Access Compliance Report

Intersection ID: 43363	Main Street: PROSPERITY_VIEW_DR	Cross Street: RIDGEVIEW_COMMONS_DR	Location: E
ADA ID: D5C129B30424	Ramp Type: PerpDiag	Initial Pass/Fail: Fail	Overall Compliance: No
		Severity Score: 8.75

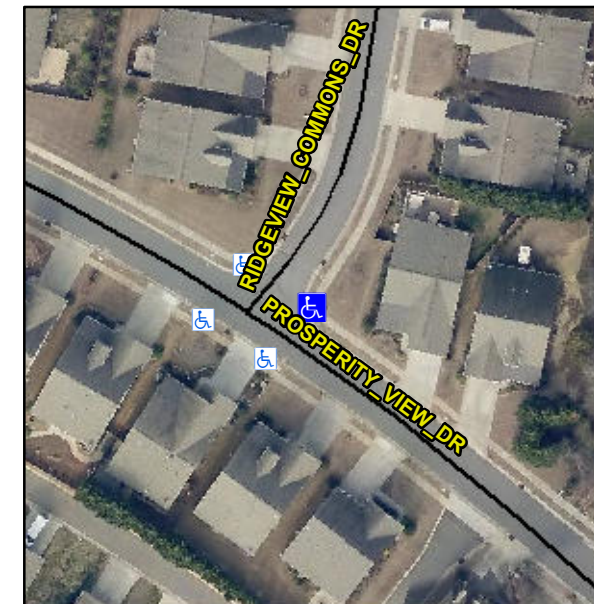
Not Found, R304.5.1

Compliance	Description	Data	Compliance	Description	Data
N/A	Ramp Length (in)	46.0	Yes	Ramp Slope (%)	7.2
No	Ramp Width (in)	38.0	Yes	Ramp XSlope (%)	1.9
N/A	Flare Type LT	N/A	N/A	Flare Type RT	N/A
N/A	Flare Slope LT (%)	N/A	N/A	Flare Slope RT (%)	N/A
N/A	Flare Traversable LT?	N/A	N/A	Flare Traversable RT?	N/A
N/A	Landing Length (in)	N/A	N/A	DWS Provided?	N/A
N/A	Landing Width (in)	N/A	N/A	DWS Contrast?	N/A
N/A	Landing Slope (%)	N/A	N/A	DWS Length (in)	N/A
N/A	Landing X Slope (%)	N/A	N/A	DWS Full Width?	N/A
N/A	Landing Curb? (Y/N)	N/A	N/A	DWS Offset (in)	N/A
N/A	Shared Landing?	N/A			
N/A	Gutter Ponding?	N/A	N/A	Gutter Slope (%)	N/A
N/A	Gutter Lip Ht (in)	N/A	N/A	Gutter X Slope (%)	N/A
N/A	Painted X Walk1?	No	N/A	Painted X Walk2?	No
	X Walk 1 Direction	To NW		X Walk 2 Direction	To SW
N/A	X Walk 1 Width (in)	N/A	N/A	X Walk 2 Width (in)	N/A
	X Walk 1 Slope (%)	0.9		X Walk 2 Slope (%)	2.7
	X Walk 1 X Slope (%)	0.7		X Walk 2 X Slope (%)	1.3

Remove & Replace Curb Ramp With Two New Directional Ramps or Equivalent.
